**Re: 2025 Build Application – Request to Hydro to Provide Additional Information – Hydro's Reply**

On March 21, 2025, Newfoundland and Labrador Hydro ("Hydro") filed its application for capital expenditures for the purchase and installation of Bay d'Espoir Unit 8 ("BDE Unit 8") and the Avalon Combustion Turbine ("Avalon CT") (collectively, "2025 Build Application"). The Board of Commissioners of Public Utilities ("Board") subsequently engaged their expert, Bates White Economic Consulting, LLC ("Bates White"), to review Hydro's submission and provide a report to the Board. Bates White submitted their report to the Board on June 26, 2025 ("Bates White Report").

In correspondence to Hydro on July 22, 2025,<sup>1</sup> the Board requested additional information on Hydro's application based on conclusions and recommendations identified within the Bates White Report. Please find enclosed Hydro's responses to the Board's request in questions 1 through 14.

Figure 8: Implied water consumption at BDE and Long Pond storage volumes during LIL shortfall<sup>307</sup>

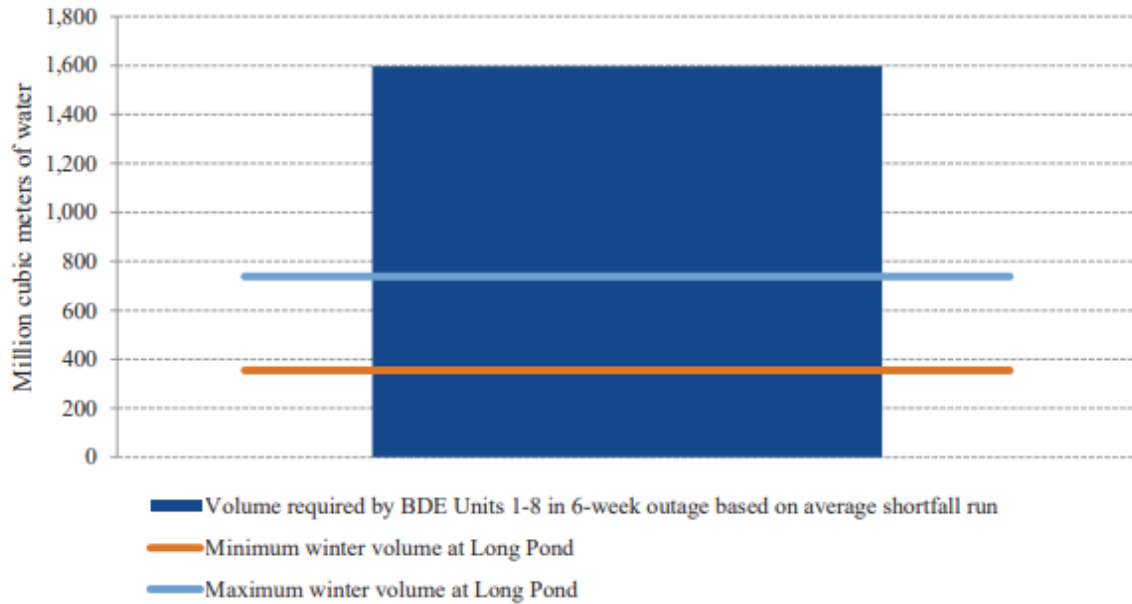
The hydrological resource constraints outlined in Section III.H of the Bates White Report, particularly Figure 8, appear to be based on a misinterpretation of the information Hydro provided and, therefore, are not valid constraints.

Hydro has not fully addressed this issue in detail in its Build Application. The March 2025 Hatch study (included in the Build Application)<sup>14</sup> contained historical inflow data at BDE.<sup>15</sup> However, that data was provided on an annual average basis which prevents assessment of seasonal inflows. In its 2024 RAP, Hydro also provided Bay d’Espoir’s average and firm energy capability given the most adverse three-year sequence of inflows in its historical record, which suggested average annual capability of 2,650 GWh and average annual firm capability of 2,096 GWh.<sup>16</sup> But this data, while useful, does not contain any seasonal granularity.

5 In their analysis in Figure 8, Bates White isolated the Long Pond Reservoir and failed to  
6 consider the water balance of the BDE system. Reservoir storage in the Long Pond Reservoir,  
7 which supplies the BDE Hydroelectric Generating Station, cannot be accurately determined  
8 by simply subtracting the maximum operating level from the low supply level, regardless of  
9 the season. Inflows into that reservoir are comprised of natural inflows from the watershed,  
10 turbined flows from the Upper Salmon Hydroelectric Generating Station, and, if necessary,  
11 bypass flows from North Salmon Dam. As a result, the reservoir receives a continuous and  
12 substantial volume of water into the Long Pond Reservoir, and its operation must adhere to  
13 defined reservoir operating limits (i.e., the maximum operating level and the low supply  
14 level).

Figure 1: Load Flow Diagram – 2034-35 Peak Load Case

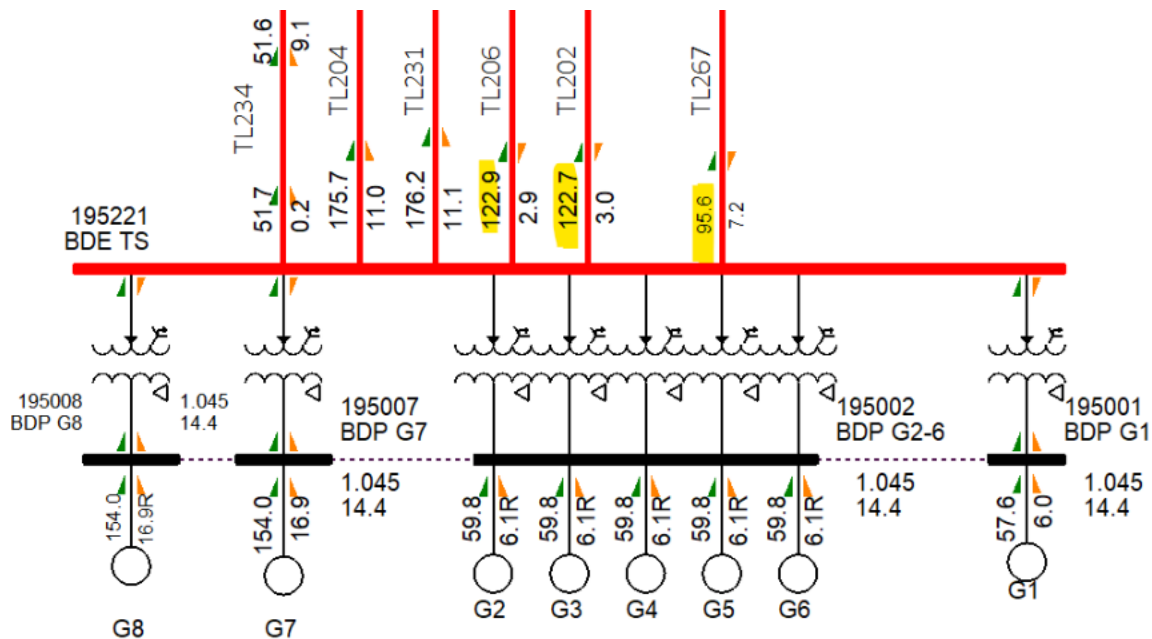
Figure 1 shows that BDE Unit 7 and 8 are at full capacity (154 MW each), while the Units 1 to 6 are at 78% of their capacity. With the LIL in service, the total transfer capacity eastward from BDE is 680 MW. Given the observed flow of 340 MW, this leaves approximately 50% of the transmission capacity unused during normal operation.<sup>34</sup> **This analysis clearly demonstrates that the BDE to SOP transmission system does not constrain Hydro’s ability to deliver BDE Unit 8 power to the Avalon Peninsula.**

**Figure 2: Load Flow Diagram – 2034–35 Peak Load Case (No Avalon Thermal Generation)**

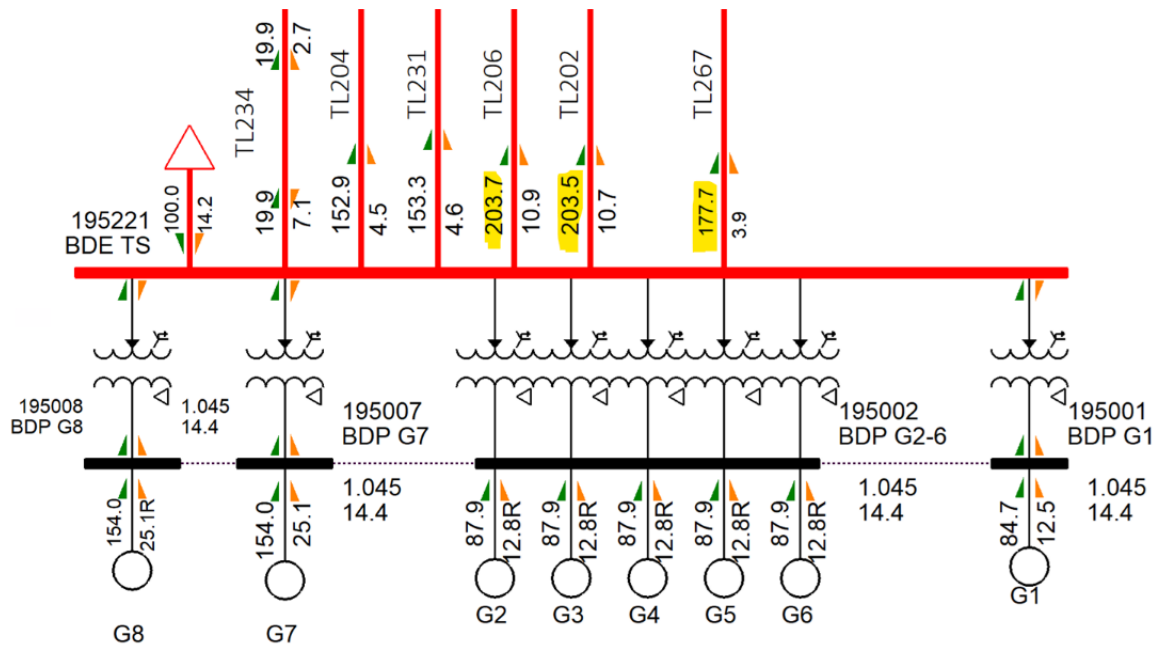
Figure 2 presents the load flow results for the same scenario with the existing Holyrood CT and the proposed Avalon CT offline. This would **not** be considered normal operation. The flow east out of BDE would be the combined flow of TL202, TL206 and TL267 of approximately 585 MW,<sup>35</sup> which would be approximately 86% of full capacity.<sup>36</sup> Under abnormal operating conditions with BDE Unit 8 in service, the 680 MW transfer limit may only be reached in exceptional circumstances.<sup>37</sup>

**In conclusion, outside of a LIL shortfall, the existing transmission is sufficient to deliver the energy from BDE 8 to the Avalon Peninsula in normal operating conditions and most abnormal operating conditions.**
